## **NEW SPRINGHILL ESTATES SUBDIVISION, UNIT 2** **RESUBDIVISION OF LOT 26**

APPLICATION NUMBER 7 DATE August 20, 2009

APPLICANT New Springhill Estates Subdivision Unit 2, Resubdivision of Lot 26

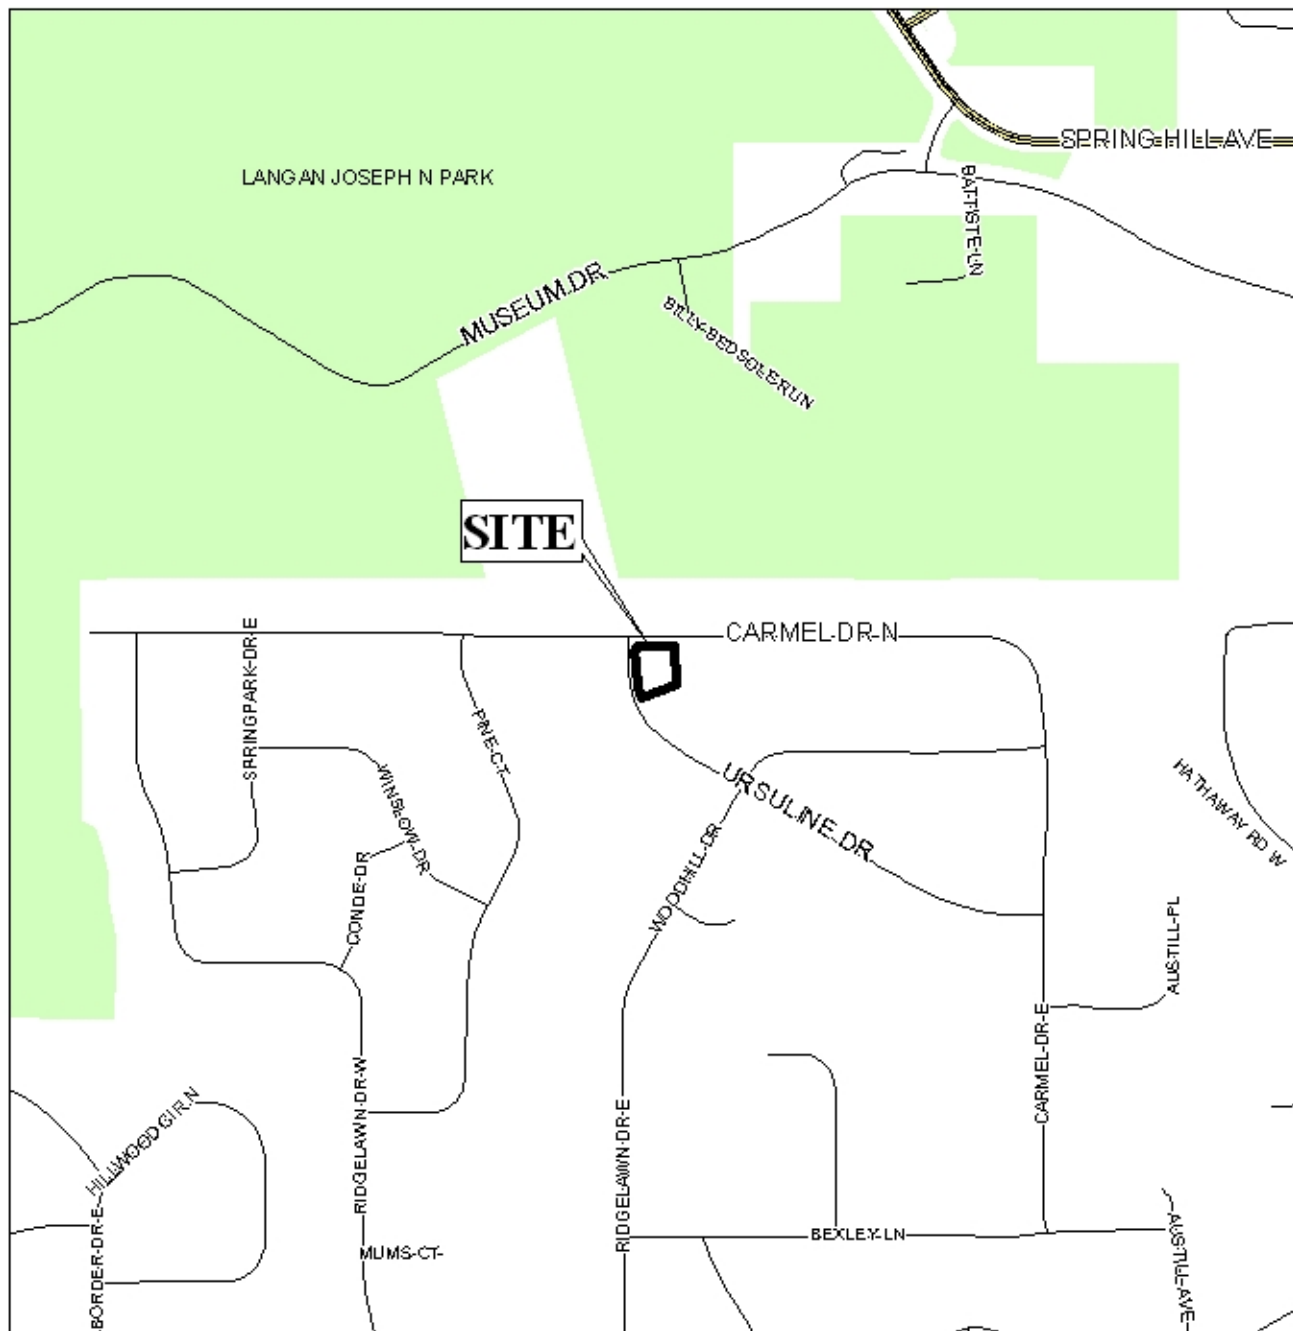
The subject lot was originally recorded with a 40' minimum building setback line from both streets. The applicant now wishes to amend the setback from Ursuline Drive only. As illustrated on the plat, the applicant is proposing a laundry / carport addition to the existing structure, which will be 20' from Ursuline Drive. Given the configuration of the subject site, Section 64-4.D.3 of the Zoning Ordinance allows a side street setback of no more than 20', which should provide the Commission enough justification in approving the applicant's request.

It should be noted that the applicant has illustrated 10' setback lines along the South and East property lines, which exceeds the minimum setback of 8'.

Furthermore, the recorded plat for New Springhill Estates Subdivision, Unit 2, depicts a 7.5' Utility and Drainage Easement along the South and East property lines of the subject lot, which is not illustrated on the preliminary plat. The applicant should revise the plat accordingly.

There appears to be an adequate radius at the intersection of Carmel Drive North and Ursuline Drive; however, the applicant should revise the site plan to illustrate compliance with Section V.B.16 of the Subdivision Regulations.

It appears that the lot meets the minimum size requirement for developments with access to public water and sewer. However, it is requested that the applicant revise the plat to label the lot with its size in square feet, or provide a table on the plat with the same information.

- 1) placement of a note on the plat stating that the site is denied direct access to Carmel Drive North and limited to one curb cut to Ursuline Drive, with the size, location, and design to be approved by Traffic Engineering and in conformance with AASHTO standards;

- 2) labeling of the lot with its size in square feet, or the provision of a table on the final plat with the same information;
- 3) revision of the plat to illustrate a 7.5' Utility and Drainage easement along the South and East property lines;

- 4) placement of a note on the final plat stating that no construction is allowed within the Utility and Drainage easement;
- 5) depiction of an adequate radius at the intersection of Carmel Drive North and Ursuline Drive;
